CITY OF GLENDALE, CA

DESIGN REVIEW STAFF REPORT – SINGLE FAMILY

February 28, 2023 <i>Decision Date</i>	1635 Don Carlos Avenue <i>Address</i>
Administrative Design Review (ADR) <i>Review Type</i>	5614-005-022 <i>APN</i>
PDR2201292 <i>Case Number</i>	Nareg Khodadadi <i>Applicant</i>
Cassandra Pruet, AICP <i>Case Planner</i>	Karlo Nazarian <i>Owner</i>

EXT'G & NEW SOUTH (FRONT) ELEVATION

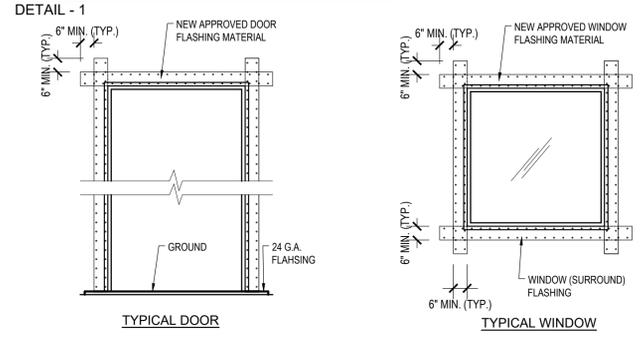
- The one-story addition is spread across the existing floor plan to slightly expand the existing building footprint while maintaining ample landscaping and open space elsewhere on site.
- The front entryway is relocated from the side façade to the front façade with a prominent entryway extending from the front façade similar to other houses on the street.
- The new entryway extending from the front façade maintains a 40-foot street front setback which is consistent with the neighborhood pattern.

- The one-story addition is well-integrated into the existing architectural style of the house because it uses the same building forms, architectural detailing, and materials. This includes gable roofs with pitches matching existing, half-timbering style wood trim, recessed windows with external grids with pattern matching existing, and exterior finish materials to match existing including stucco siding and roofing.

1. New half-timber style wood trim to match dimensions, depth within the stucco, and color of existing.
 2. Any landscaping replaced on site during construction is subject to review by planning and must be low-water use for Glendale and comply with the Comprehensive Design Guidelines.
-
